# **SAFETY ANALYSIS REPORT**

## **Revision 16d**

Figure 2.1-1 LES Corporate, Design and Construction Organization

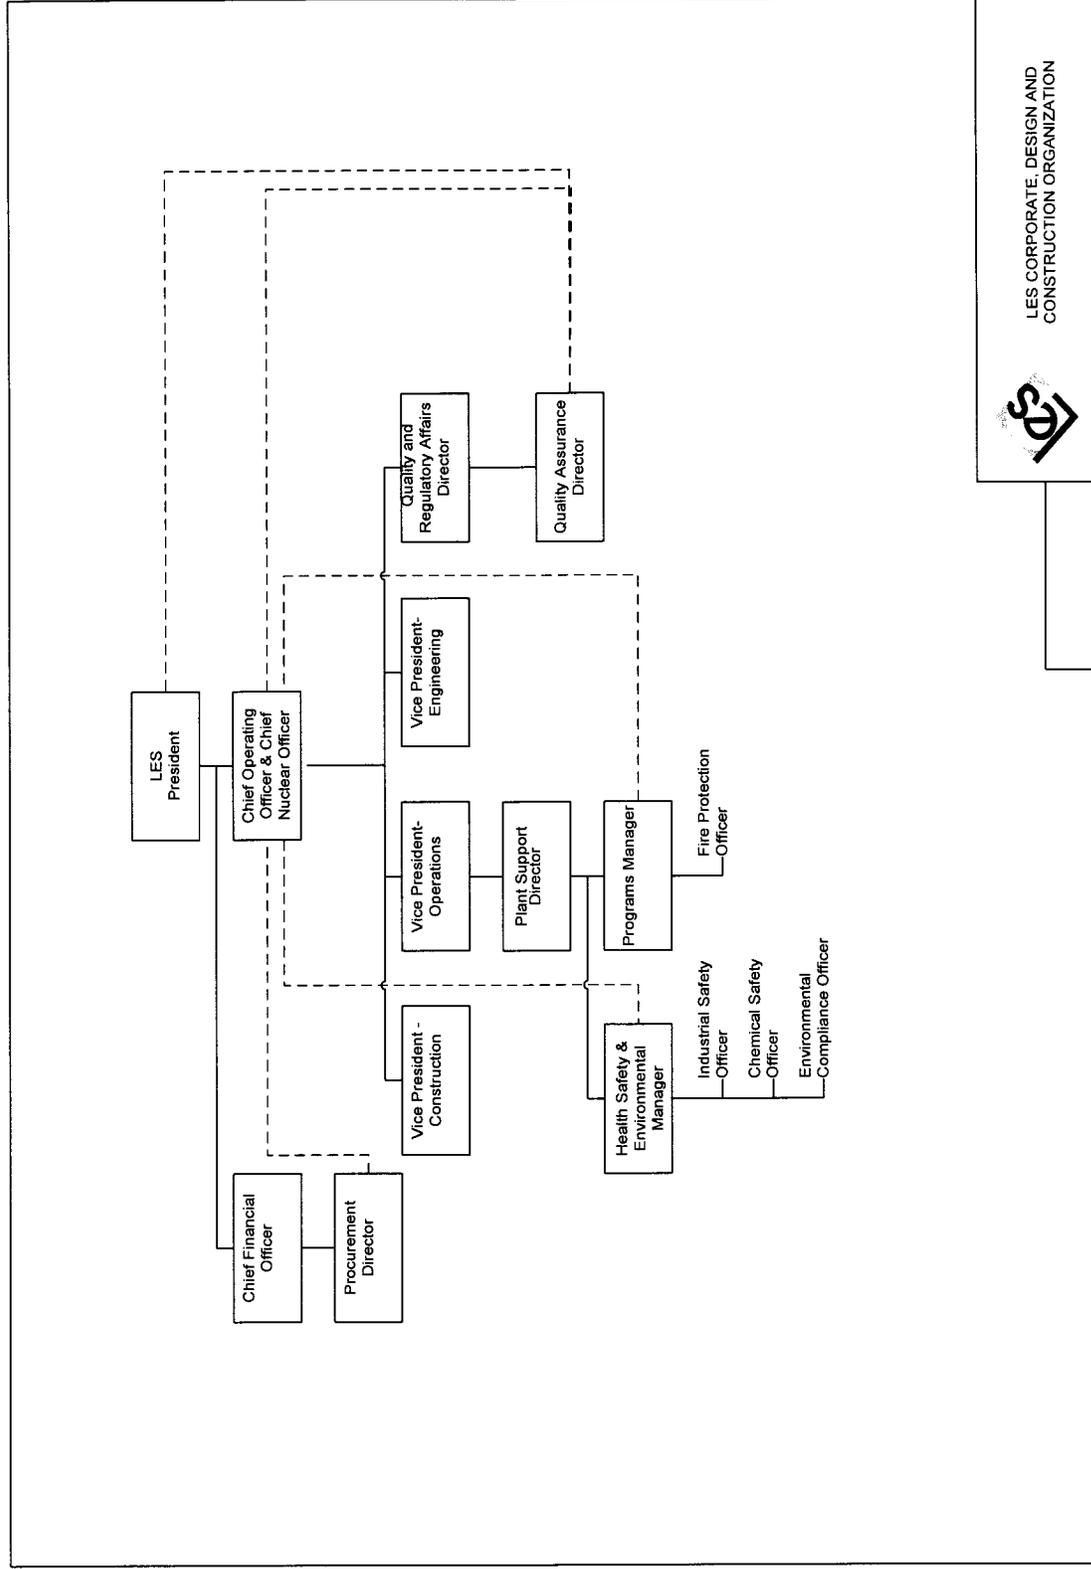
~~The Director of Construction & Project Implementation~~ Vice President of Construction is responsible for managing the work and contracts. ~~The Project Controls Director is responsible for scheduling and project financial controls and reports directly to the Chief Operating Officer and Chief Nuclear Officer.~~ The lines of communication of key management positions within the engineering and construction organization are shown in Figure 2.1-1.
